OCONEE 1

OFFSITE DOSE CALCULATION MANUAL REVISION 38

Subject: Offsite Dose Calculation Manual (ODCM)
Generic Section - Revision 38

JUSTIFICATION FOR REVISION 38

**LIQUID RADWASTE SYSTEM
 OCONEE NUCLEAR STATION
 Figure A1.0-1**

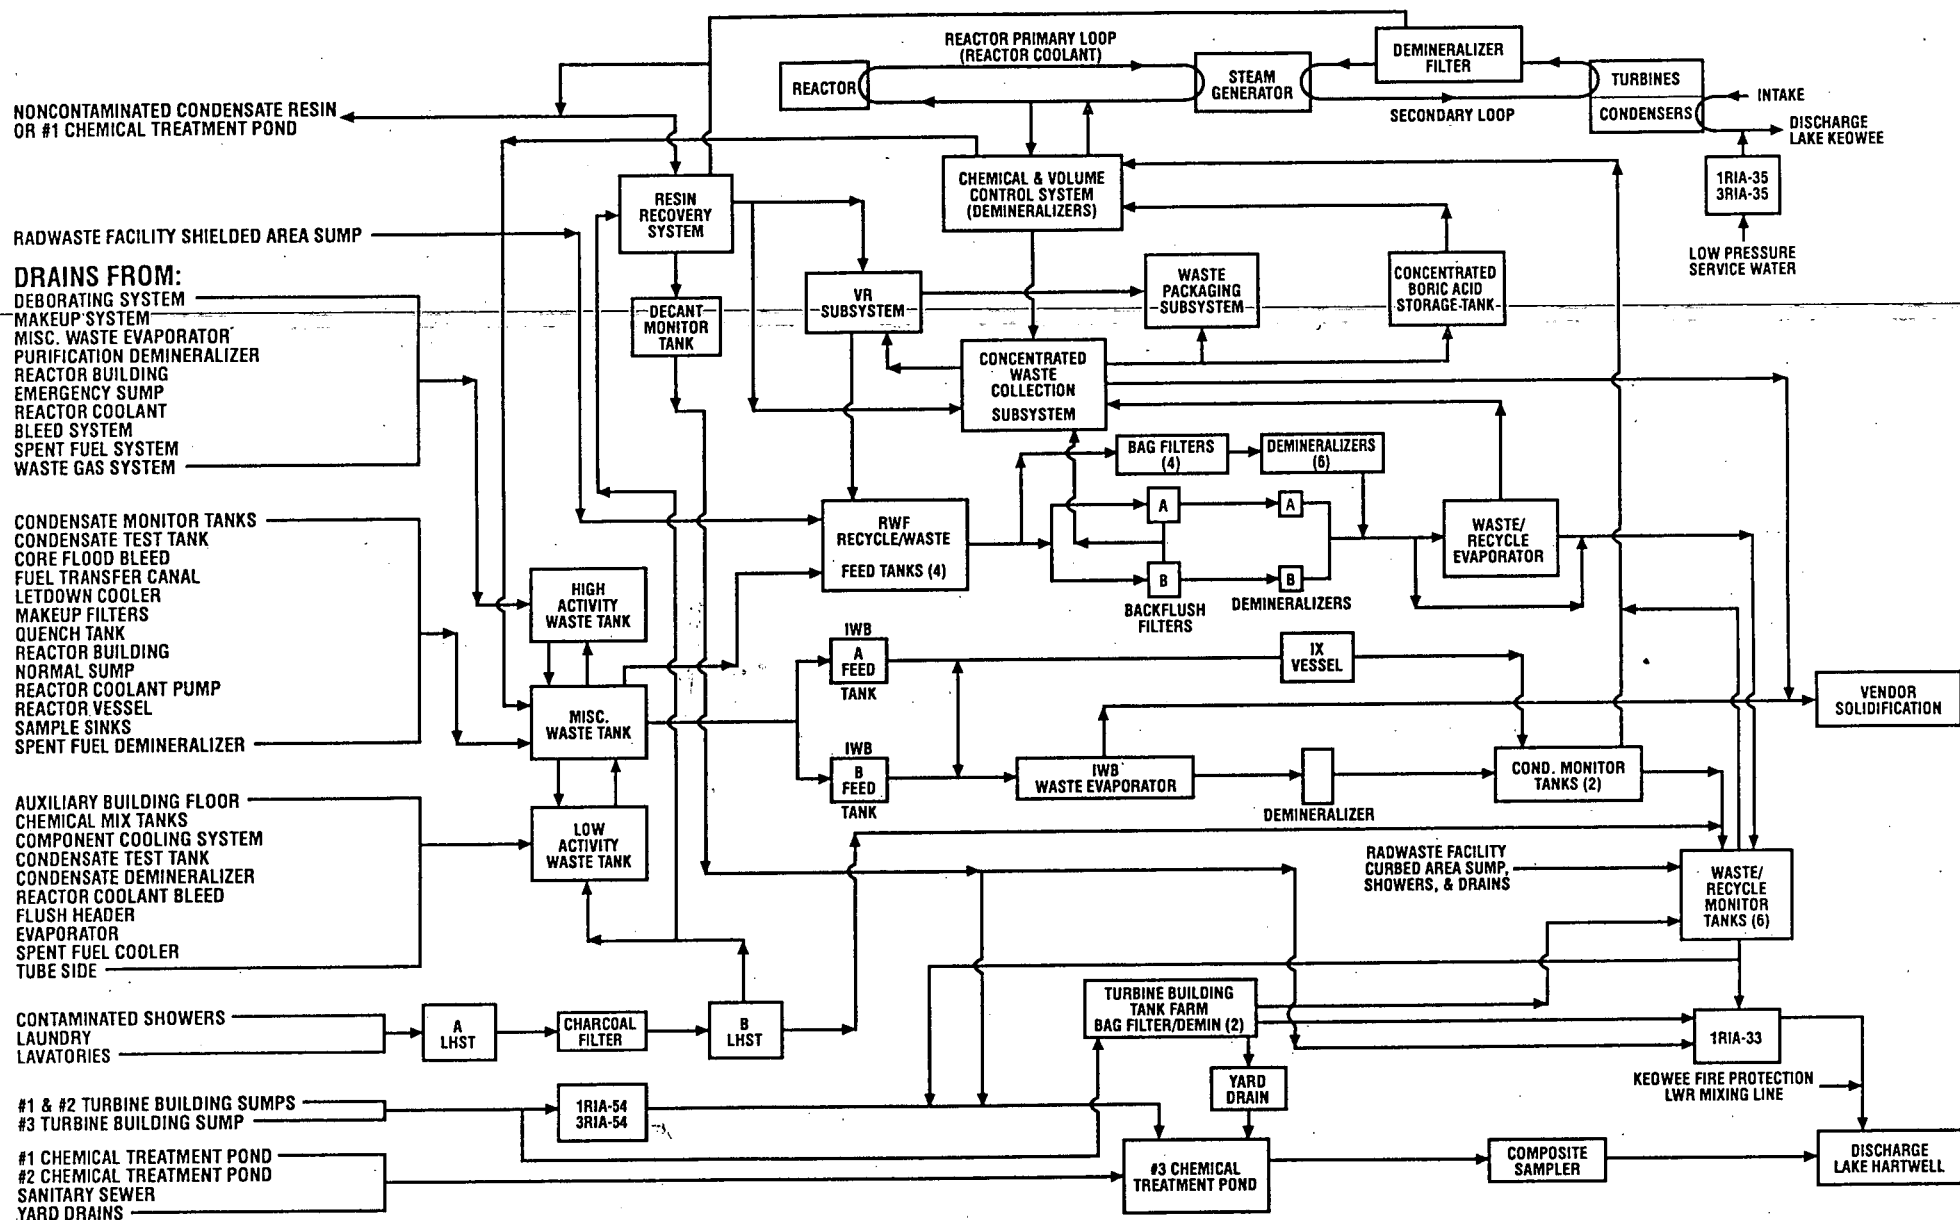
Figure A1.0-1

Replaced figure with CAD drawing.
Updated to reflect actual station operation and/or to provide additional information.

Figure A1.0-1

Incorporated Radwaste Facility into drawing.

GASEOUS WASTE SYSTEM
 OCONEE NUCLEAR STATION
 FIGURE A1.0-2
 PAGE 1 OF 4

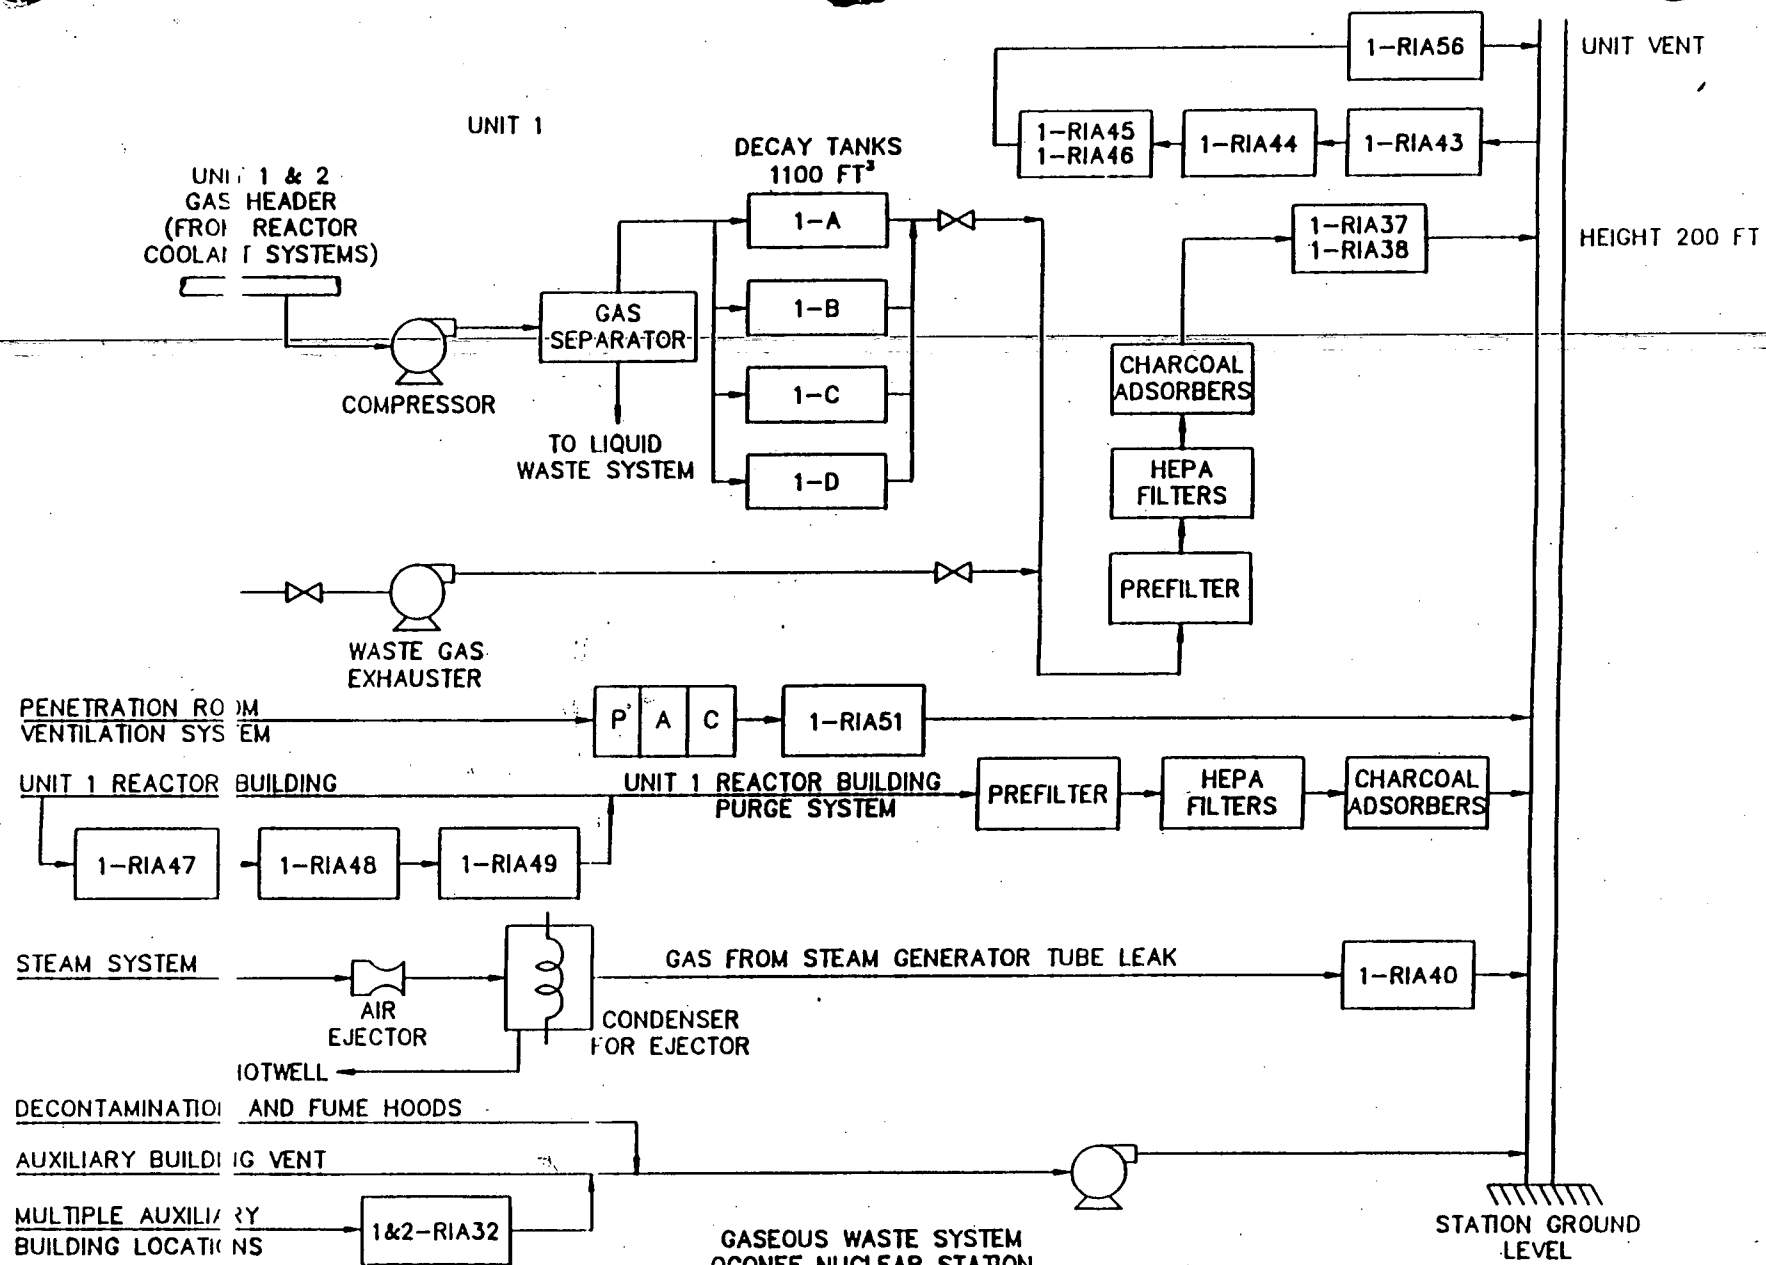
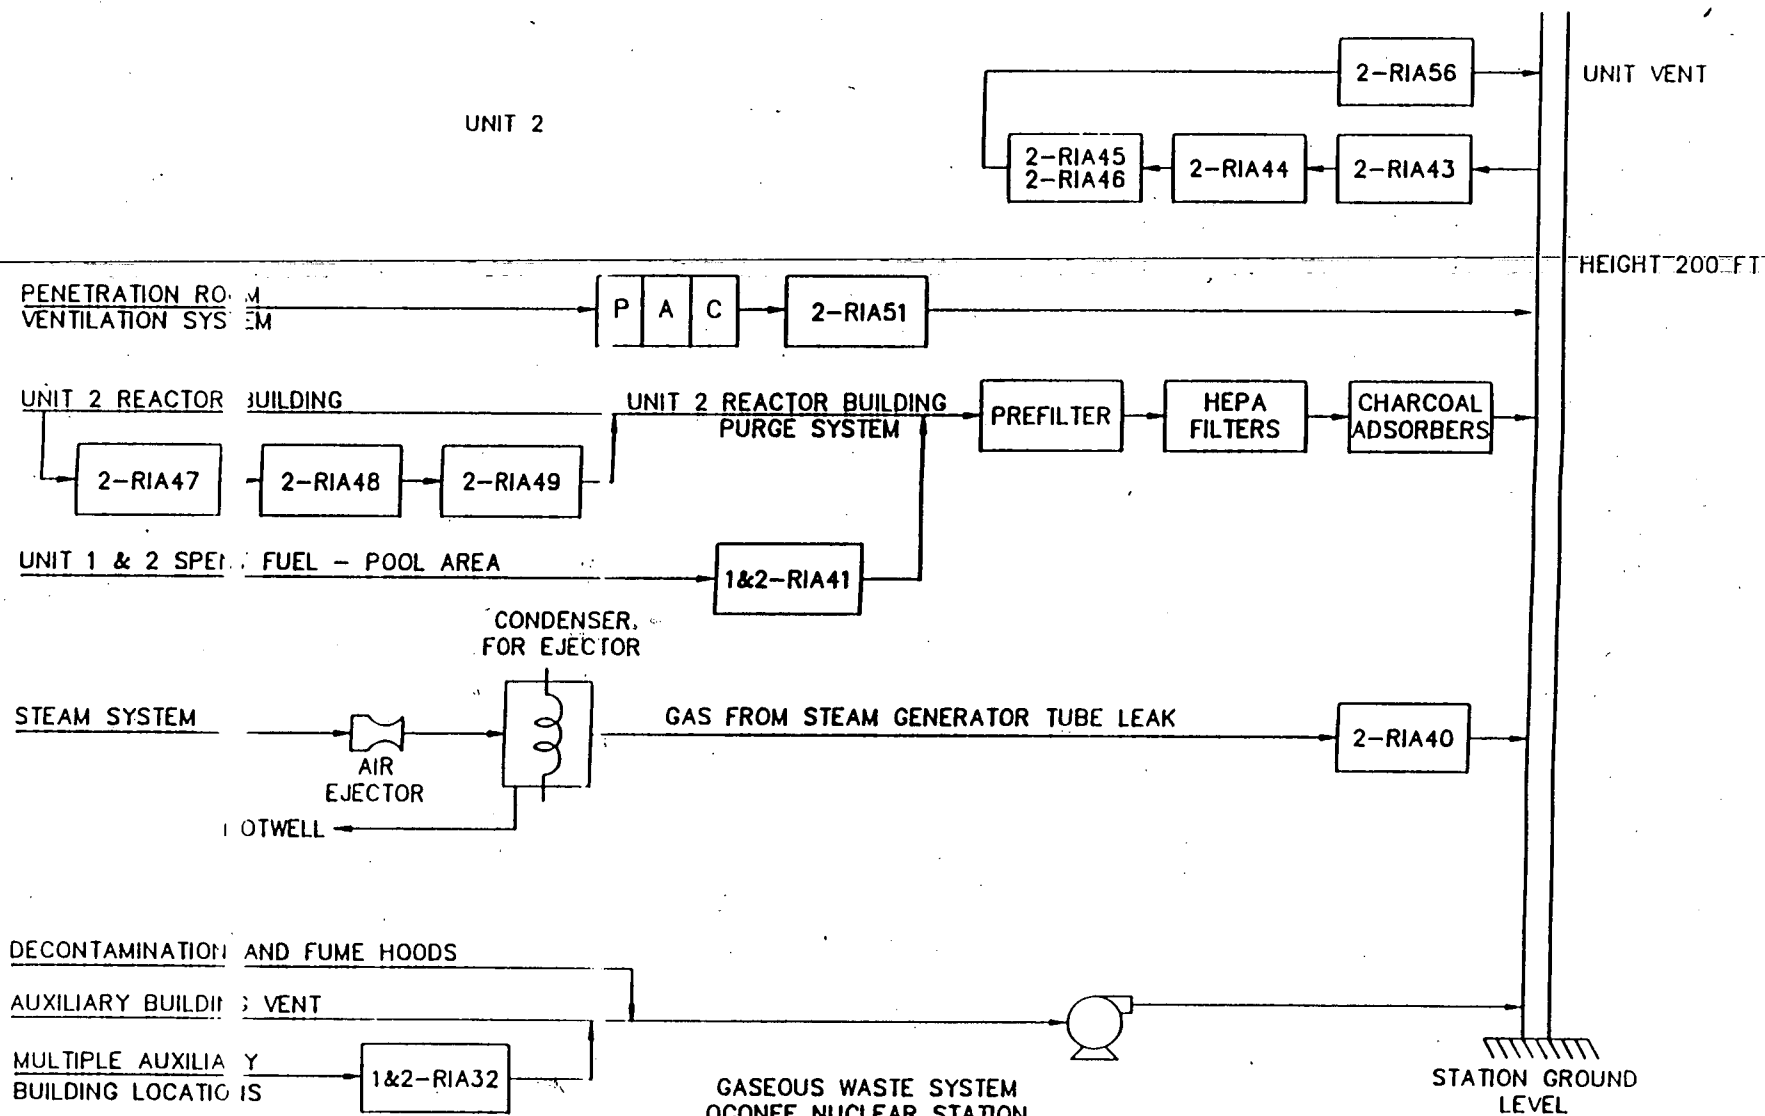
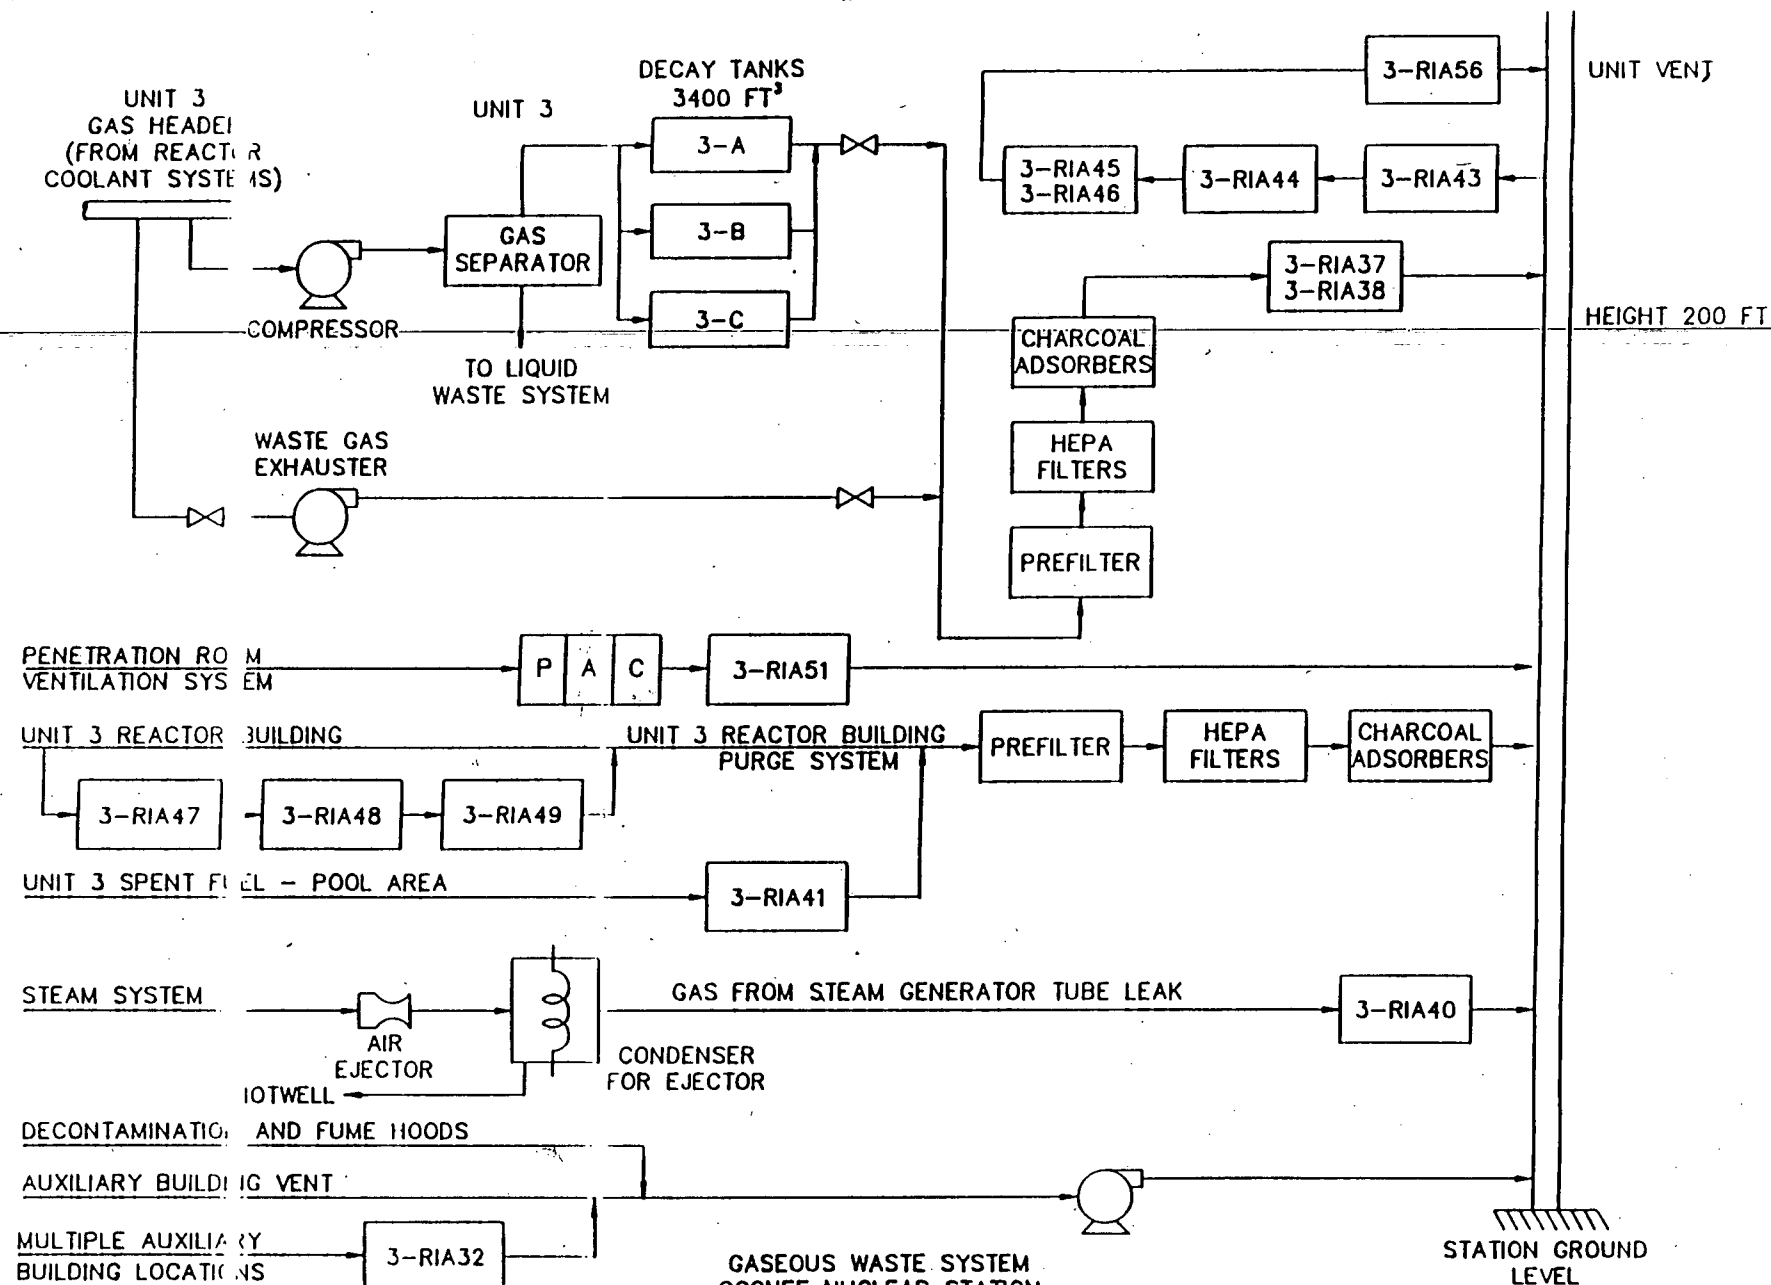
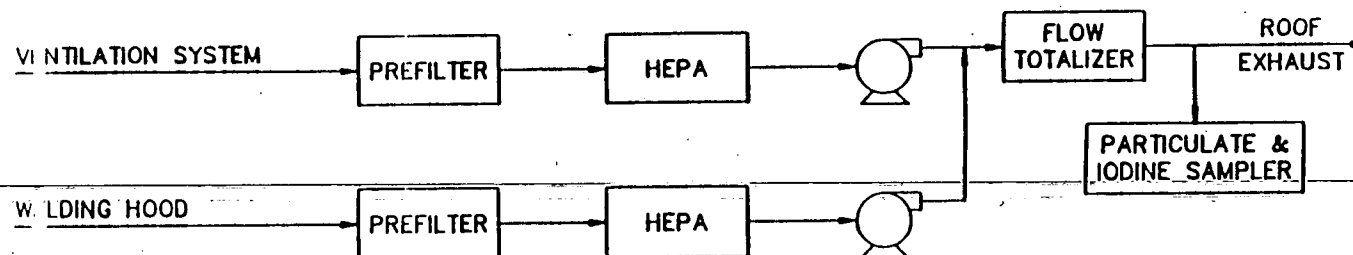
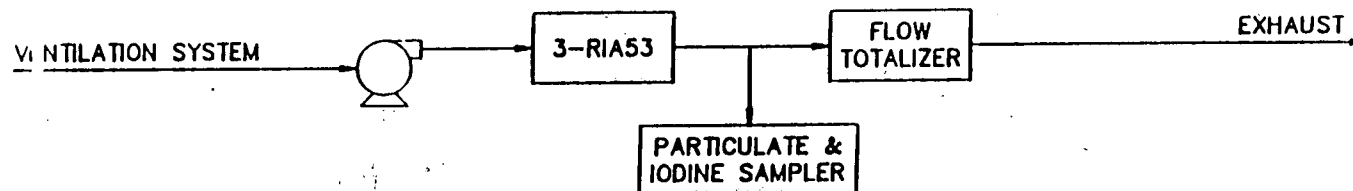
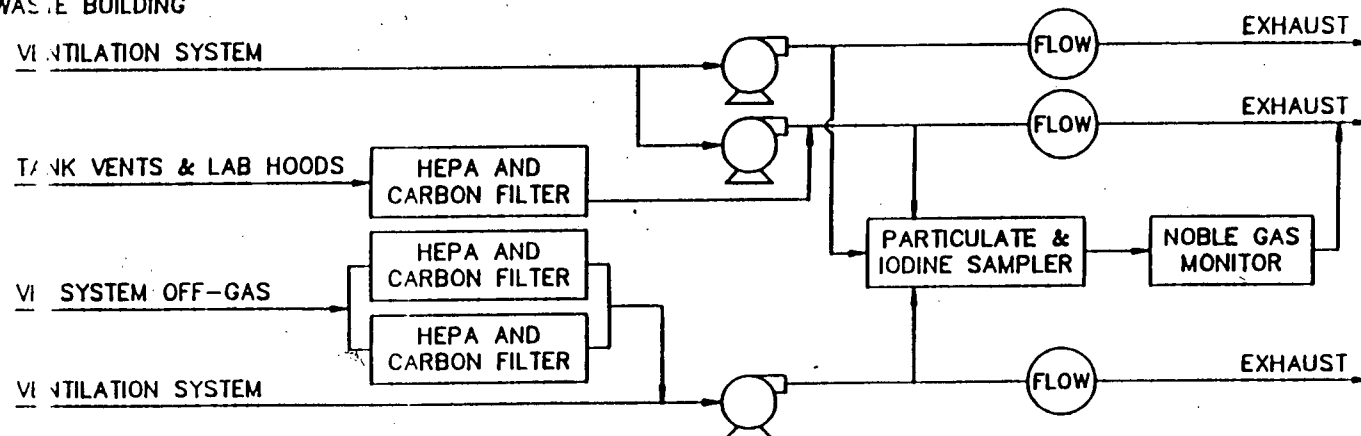
Figure A1.0-2
(4 pages)

Replaced figure with CAD drawing.
Updated to reflect actual station operation and/or to provide additional information.

Figure A1.0-2
(Page 4 of 4)

Incorporated Radwaste Facility into drawing.
